Access Compliance Report

Public Rights-of-Way

(Curb Ramps)

Intersection ID: 10019902	Main Street: ARCO_CORPORATE_DR	Cross Street: N/A	Location: NE
ADA ID: 82FB86B4D4F6	Ramp Type: PerpDiag	Initial Pass/Fail: Fail	Overall Compliance: No
Codes/Mitigation Info/Possible Solution		Field Measurements/Component Compliance

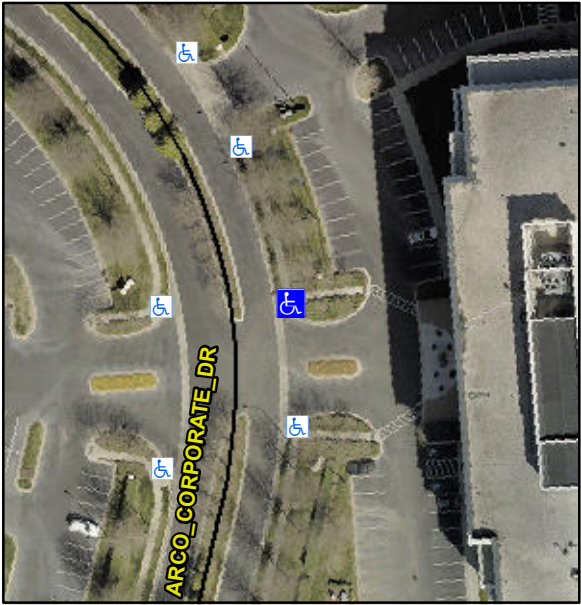
Possible Solutions:	Compliance	Description	Data	Compliance	Description	Data
	Remove & Replace Curb Ramp With Two New Directional Ramps or Equivalent.	N/A	Ramp Length (in)	31.0	Yes	Ramp Slope (%)	5.1
		Yes	Ramp Width (in)	48.0	No	Ramp XSlope (%)	9.7
		N/A	Flare Type LT	N/A	N/A	Flare Type RT	N/A
		N/A	Flare Slope LT (%)	N/A	N/A	Flare Slope RT (%)	N/A
		N/A	Flare Traversable LT?	N/A	N/A	Flare Traversable RT?	N/A
		N/A	Landing Length (in)	N/A	N/A	DWS Provided?	N/A
		N/A	Landing Width (in)	N/A	N/A	DWS Contrast?	N/A
		N/A	Landing Slope (%)	N/A	N/A	DWS Length (in)	N/A
		N/A	Landing X Slope (%)	N/A	N/A	DWS Full Width?	N/A
		N/A	Landing Curb? (Y/N)	N/A	N/A	DWS Offset (in)	N/A
		N/A	Shared Landing?	N/A			
		N/A	Gutter Ponding?	N/A	N/A	Gutter Slope (%)	N/A
		N/A	Gutter Lip Ht (in)	N/A	N/A	Gutter X Slope (%)	N/A
		N/A	Painted X Walk1?	No	N/A	Painted X Walk2?	No
			X Walk 1 Direction	To W		X Walk 2 Direction	To S
		N/A	X Walk 1 Width (in)	N/A	N/A	X Walk 2 Width (in)	N/A

X Walk 1 Slope (%)	5.3		X Walk 2 Slope (%)	7.2
			X Walk 1 X Slope (%)	4.1		X Walk 2 X Slope (%)	5.4
		N/A	Ramp inside XWalk1?	N/A	N/A	Ramp inside XWalk2?	N/A
<p>Surveyor Notes:</p> <p>N/A</p> <p>PROW/ADA:</p> <p>Not Found, R304.5.3</p>			Road Slope (%)	6.2	N/A	Clear Space?	N/A
			Road X Slope (%)	0.2	N/A	Clear Space to XWalk (in)	N/A
		N/A	Any Obstructions?	N/A	N/A	Storm Grate/Utility Hazard?	N/A
			Obstruction Type			Storm Grate/Utility Type	
Total Cost:			\$	3200.00	N/A		N/A
					Yes	Surface Condition? (G/P)	Good
